To: T10 Technical Committee
From: Rob Elliott, HP (elliott@hp.com)
Date: 1 December 2004
Subject: 04-370r1 SAS-1.1 Merge IT and IR with XT and XR

Revision 1 (1 December 2004) Incorporated comments from November SAS Physical WG. Updated all the figures to use transmitter/receiver circuit/device terminology and show where test loads are applied. Separated the concept of transmitter device testing and receiver device tolerance testing.

Figure 1 — External cable CT and CR compliance points

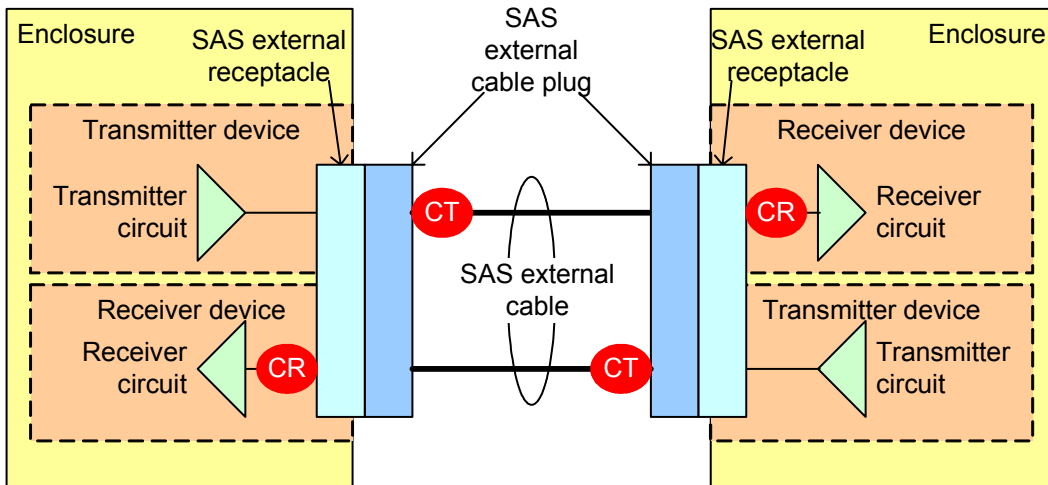
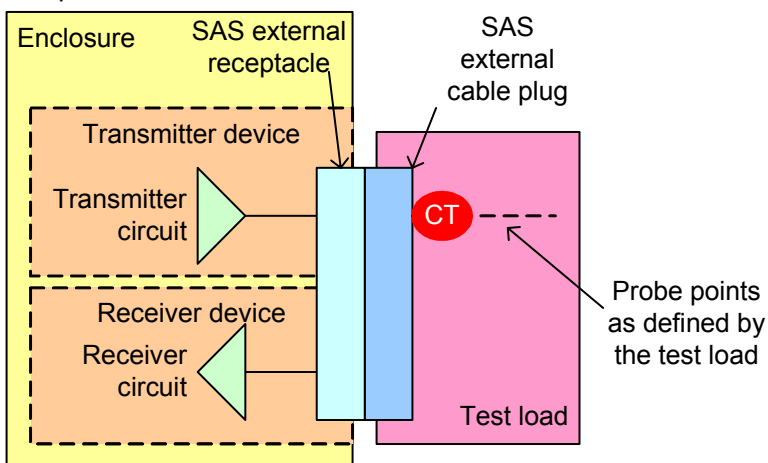
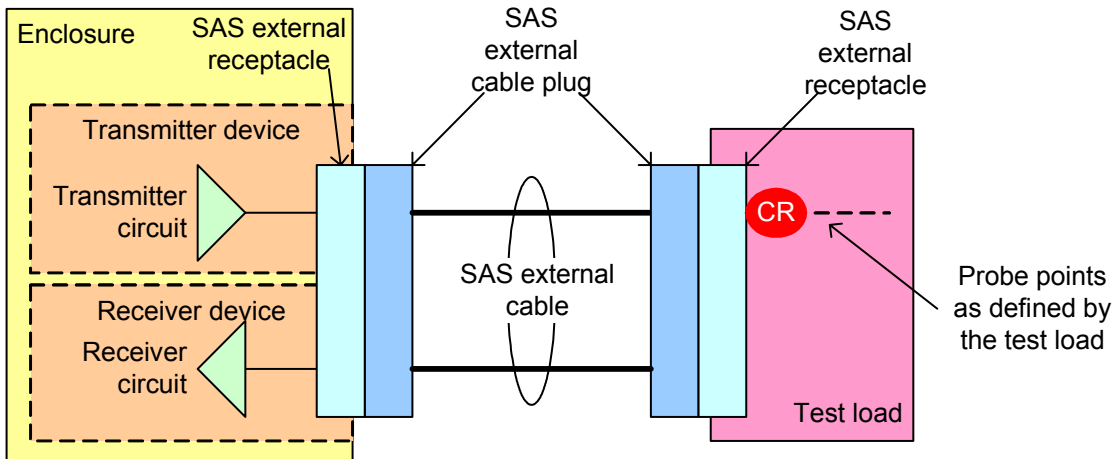
2. There is some confusion over where exactly the compliance points are located. Proposed figures are added showing the location of the compliance points for each type of connector interface and how the test loads are used to test compliance at those points.

Figure 1 shows the locations of the CT and CR compliance points using an external cable, and shows how two of the compliance points are tested using test loads with SAS external connectors (see figure 68 and figure 69 in 5.3.11).

Figure 2 — Backplane IT and IR compliance points

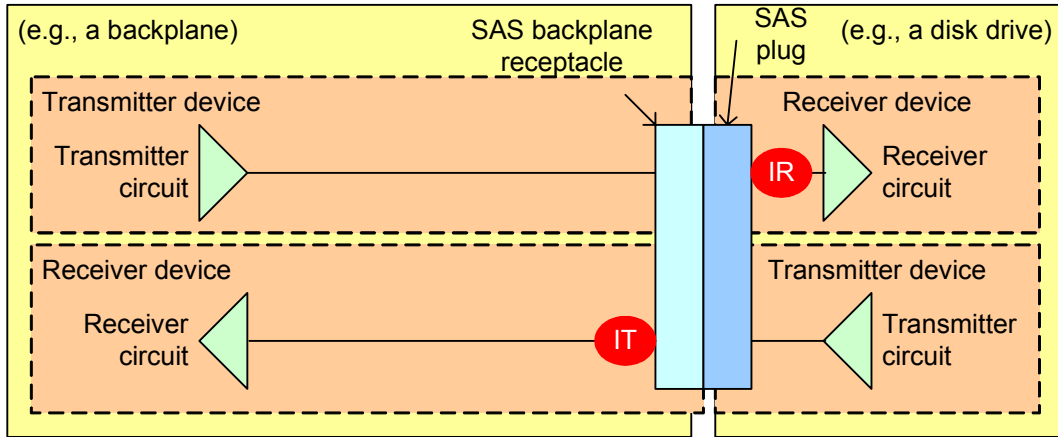
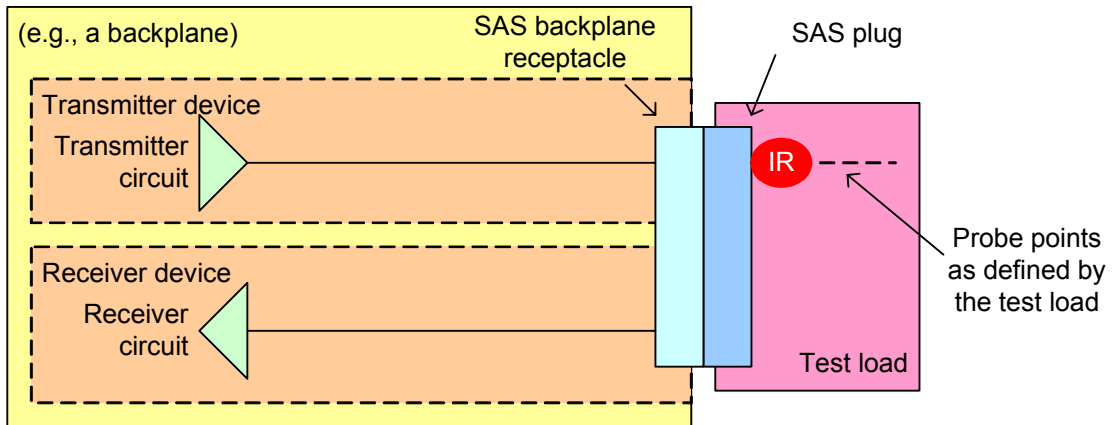
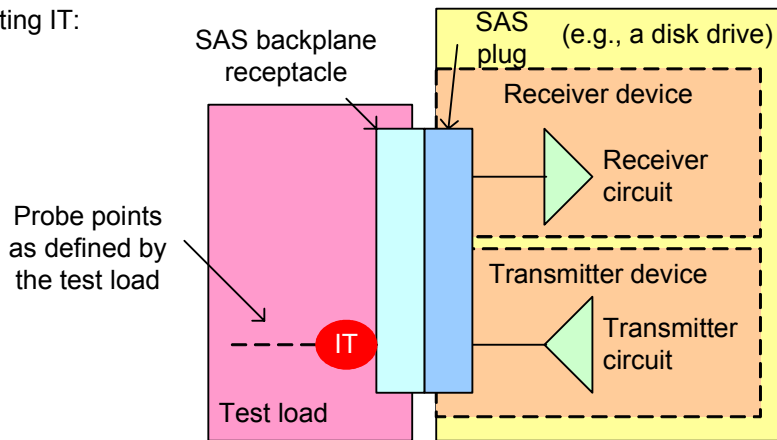
Figure 2 shows the locations of the IT and IR compliance points using a backplane with a SAS backplane receptacle (see 5.2.3.4) that is not attached to a SATA device, and shows how the compliance points are tested using test loads with SAS internal connectors (see figure 68 and figure 69 in 5.3.11).

Figure 3 — Backplane compliance points with SATA device attached

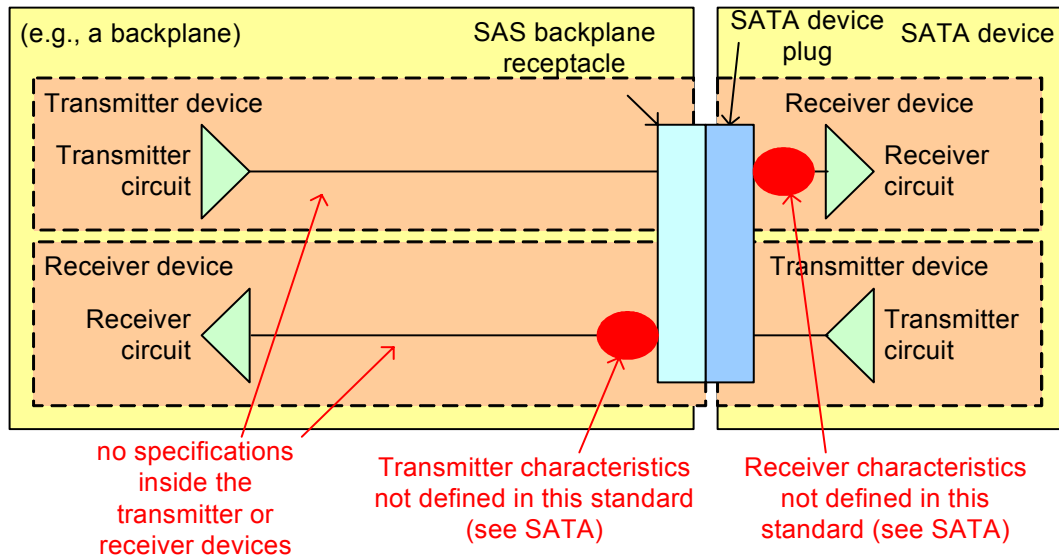
If the backplane supports SATA devices being attached to the SAS backplane receptacle (see 5.2.3.4), there are no IT or IR compliance points. SATA defines the signal characteristics that the SATA device delivers and that the SAS backplane is required to deliver to the SATA device, as shown in figure 3.

Figure 4 — Internal wide cable IT and IR compliance points

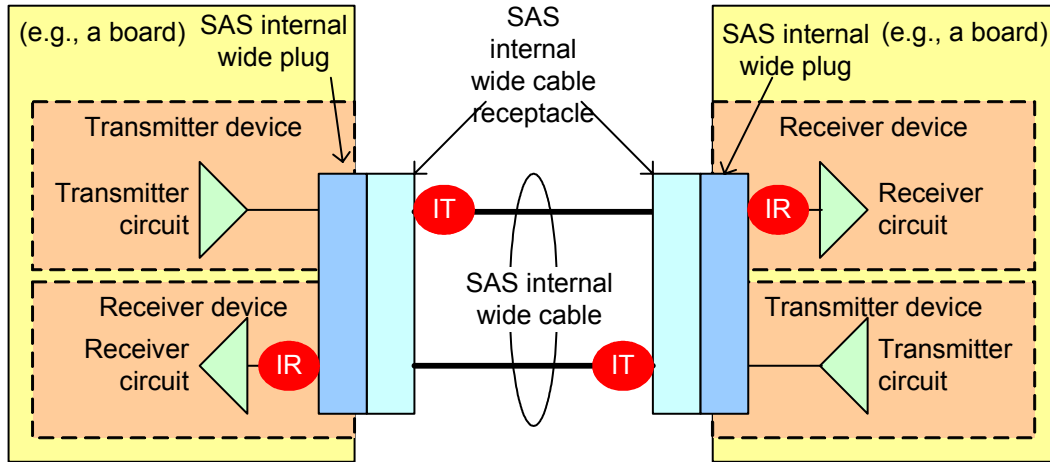
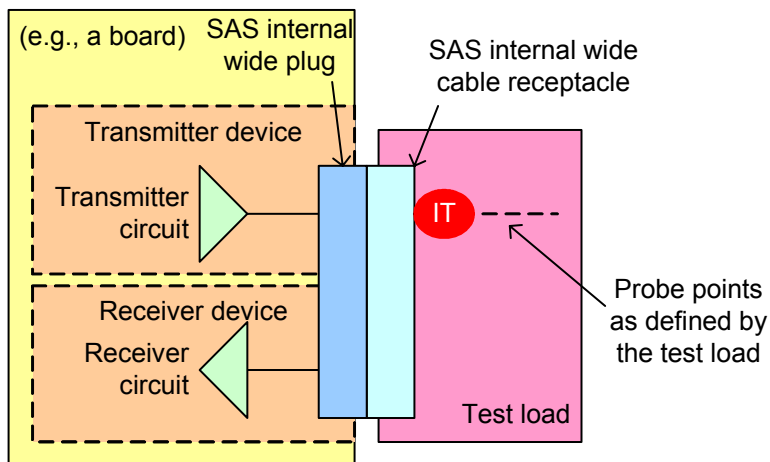
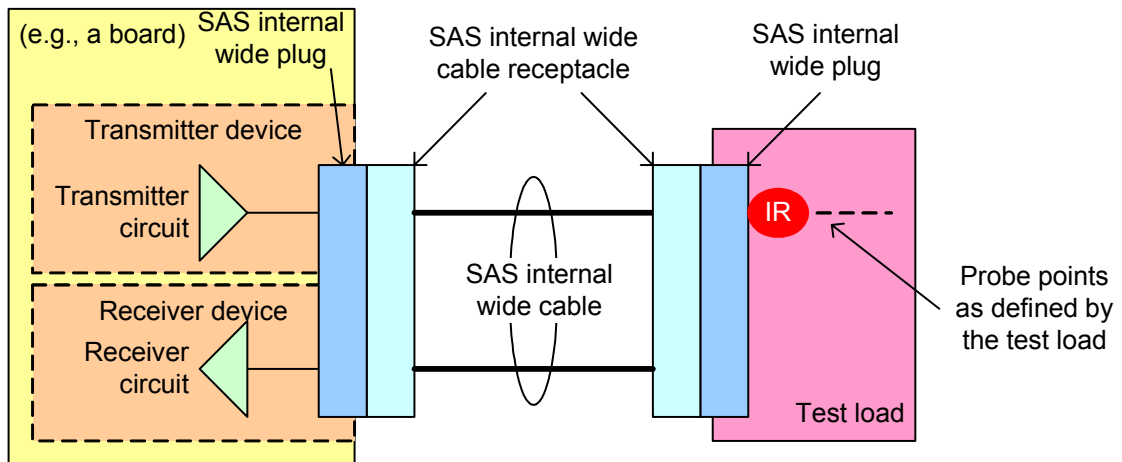
Figure 4 shows the locations of the IT and IR compliance points using an internal wide cable, and shows how two of the compliance points are tested using test loads with SAS internal connectors (see figure 68 and figure 69 in 5.3.11).

Figure 5 — Internal wide cable and backplane IT and IR compliance points

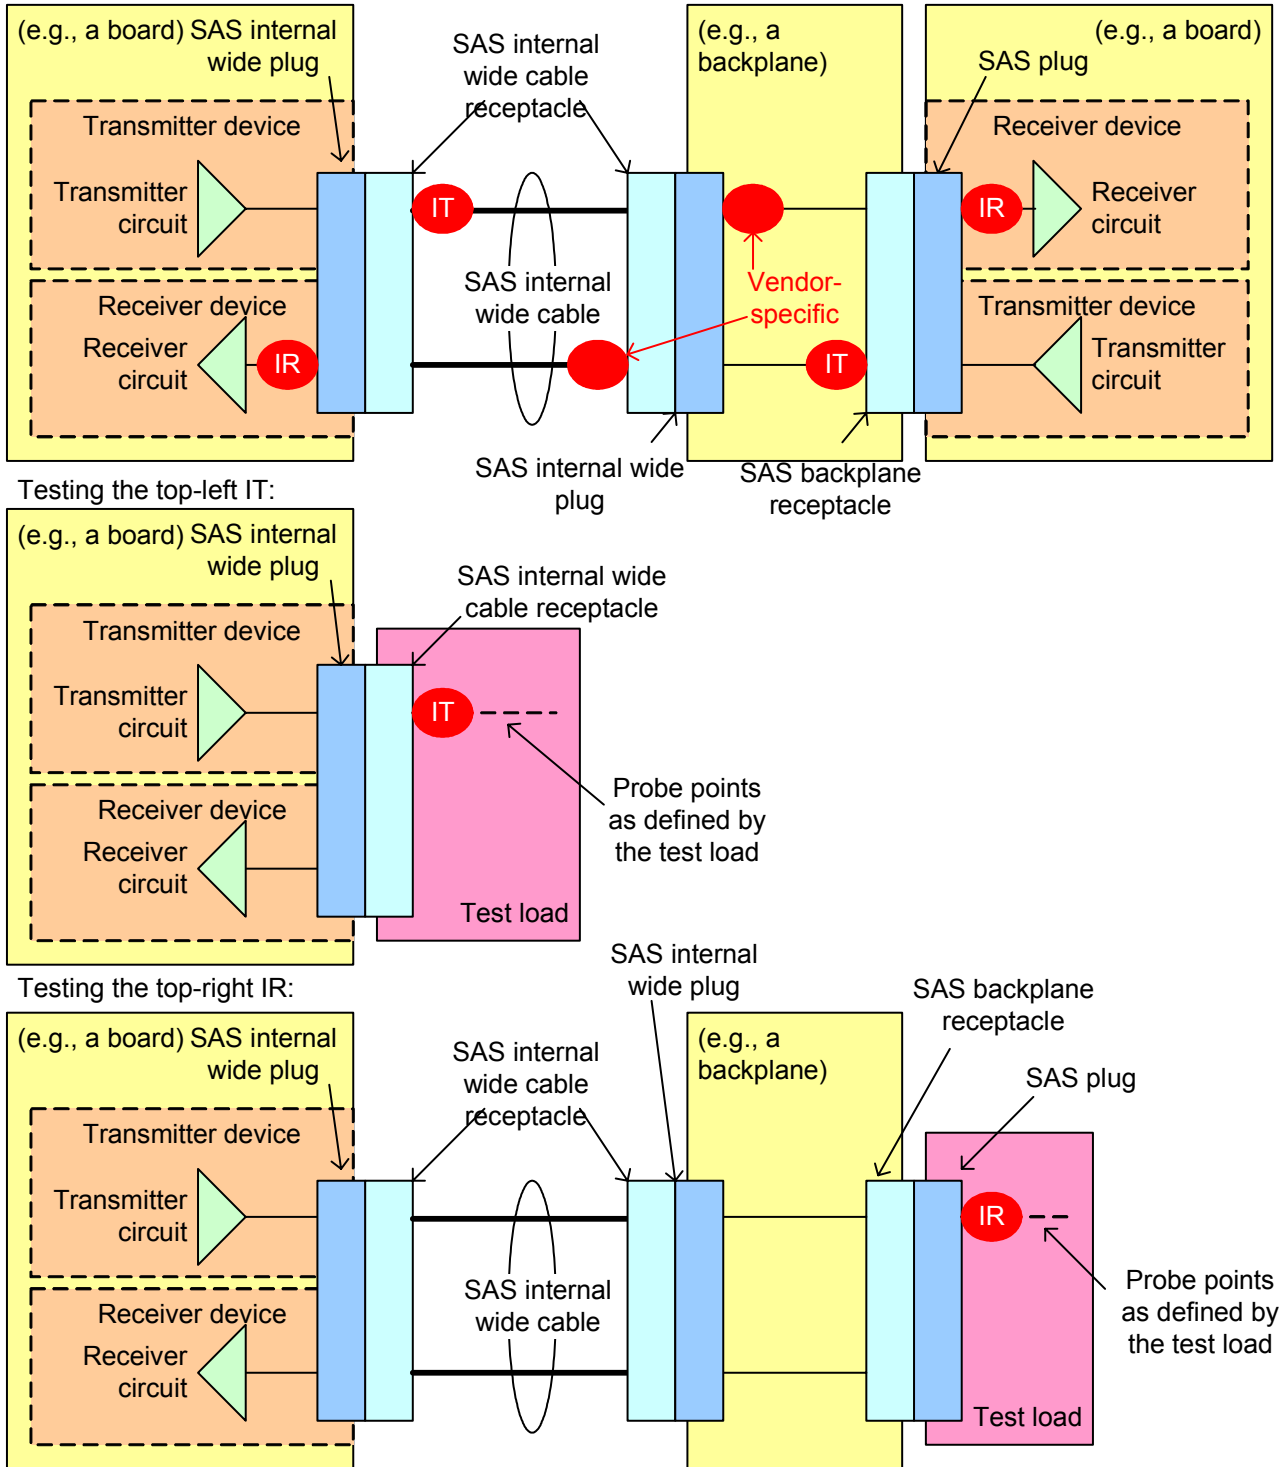
Figure 5 shows the locations of the IT and IR compliance points using an internal wide cable and a backplane, where the backplane is not attached to a SATA device. It also shows how two of the compliance points are tested using test loads with SAS internal connectors (see figure 68 and figure 69 in 5.3.11)

Figure 6 — Internal cable and backplane compliance points with SATA device attached

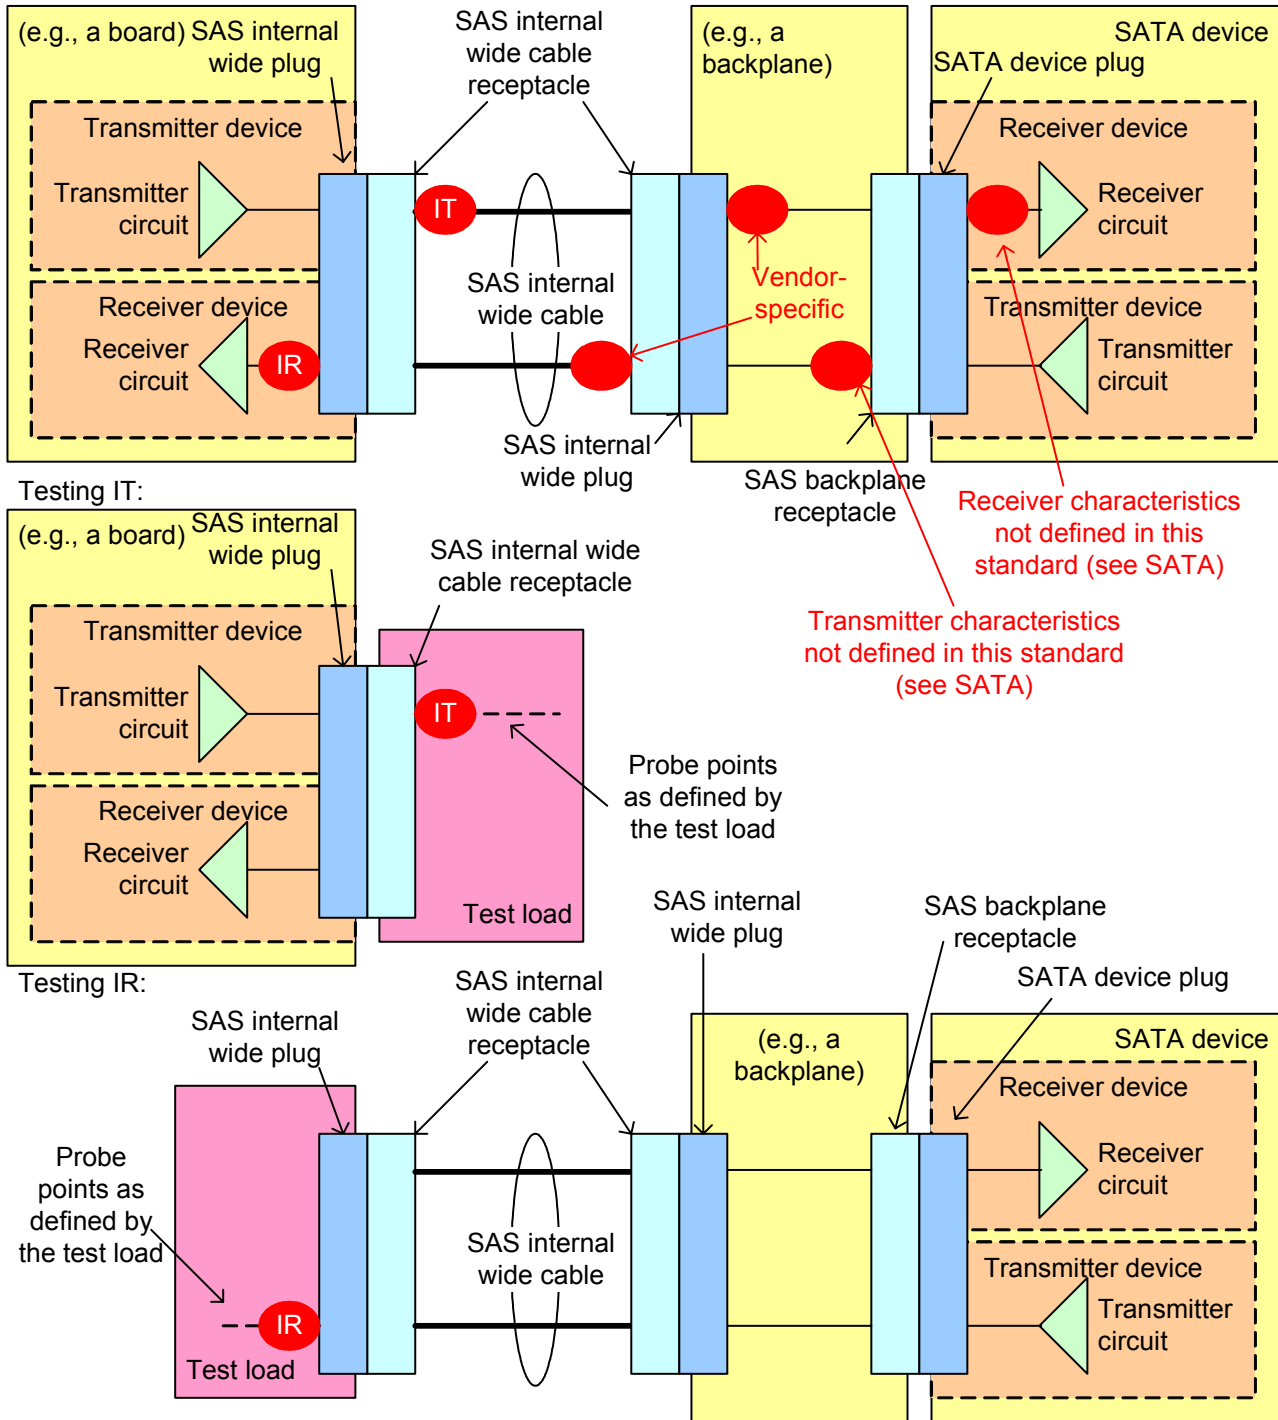
Figure 6 shows the locations of the IT and IR compliance points using an internal wide cable and a backplane, where the backplane supports being attached to a SATA device. There are no IT and IR compliance points at the SAS backplane receptacle connector when a SATA device is attached; SATA defines the signal

characteristics that the SATA device delivers and that the SAS backplane is required to deliver to the SATA device. There are compliance points at the internal wide connector, however.

Figure 7 — Internal cable IT and IR compliance points

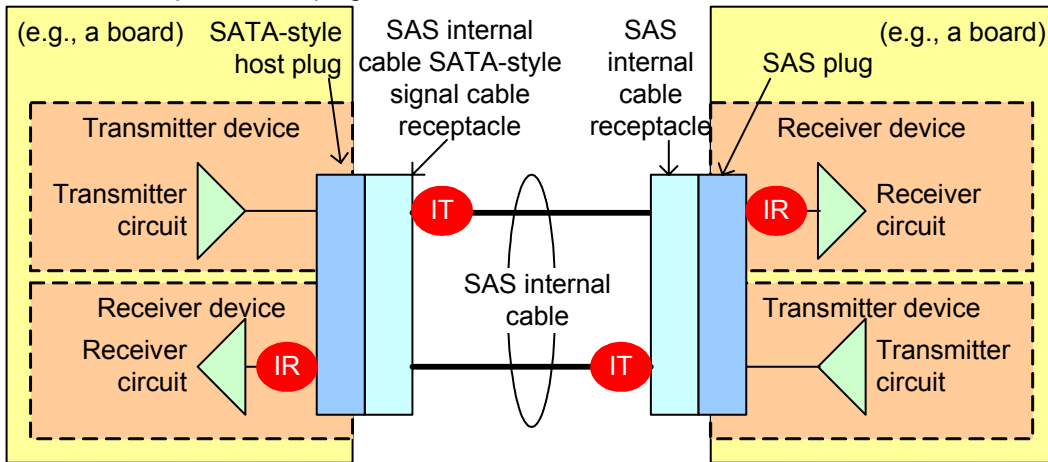
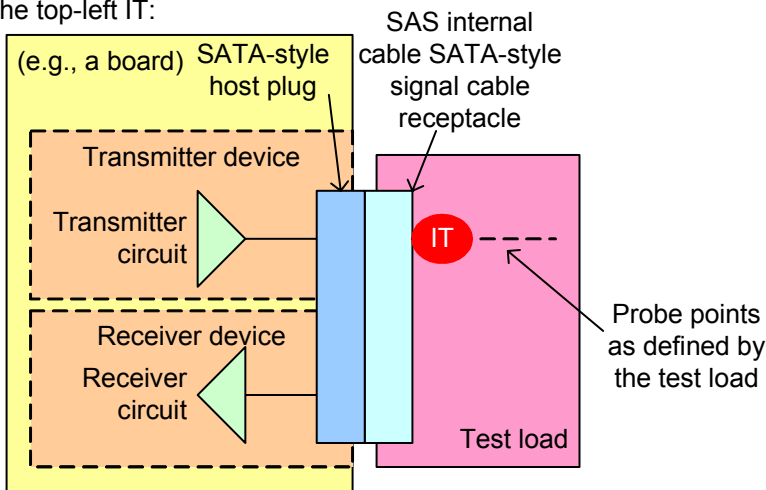
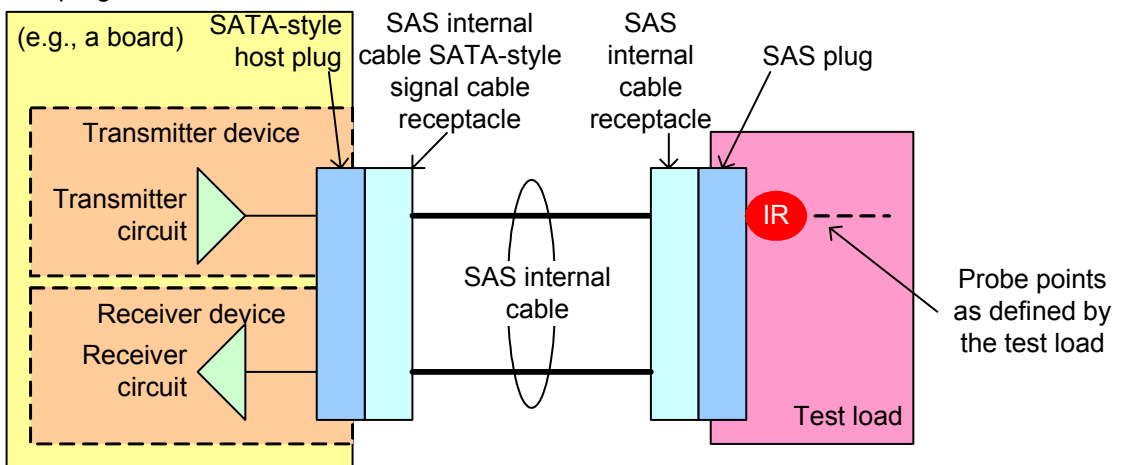
Figure 7 shows the locations of the IT and IR compliance points using an internal cable.

Figure 8 — Transmitter **device** transient test circuit

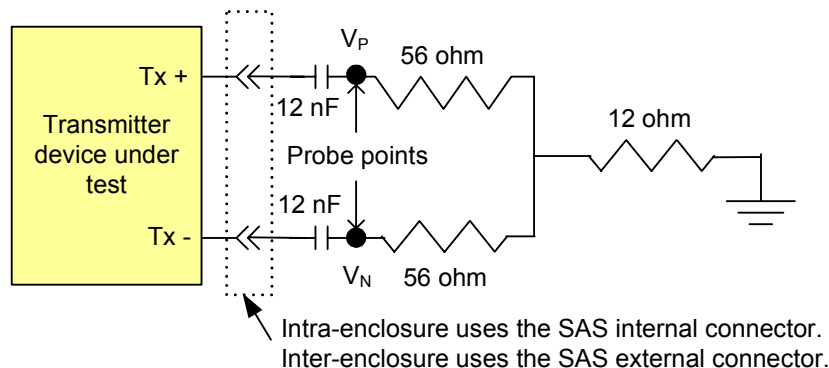
Figure 8 shows the **transmitter transient** test circuit [attached to IT or CT to test transmitter device transients](#).

Figure 9 — Receiver **device** transient test circuit

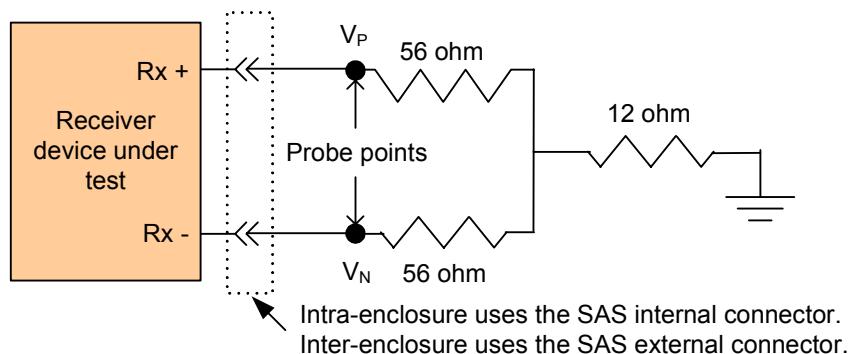
Figure 9 shows the **receiver transient** test circuit [attached to IT or CT used to test receiver device transients](#).

Figure 11 — ~~Eye mask at IR, CR, and XR~~ Receiver device eye mask

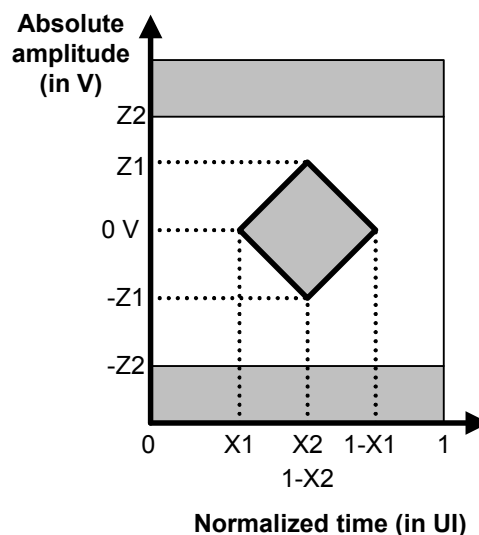
Figure 11 describes the ~~receive~~ eye mask ~~used for testing the signal delivered to the receiver device at IR and CR~~. The signal shall be measured using a jitter timing reference (e.g., a golden PLL) that approximates a single pole (i.e., 20 dB per decade) low-pass filter with corner frequency of $((\text{bit rate}) / 1667)$. This requirement accounts for the low frequency tracking properties and response time of the CDRs in receiver devices.
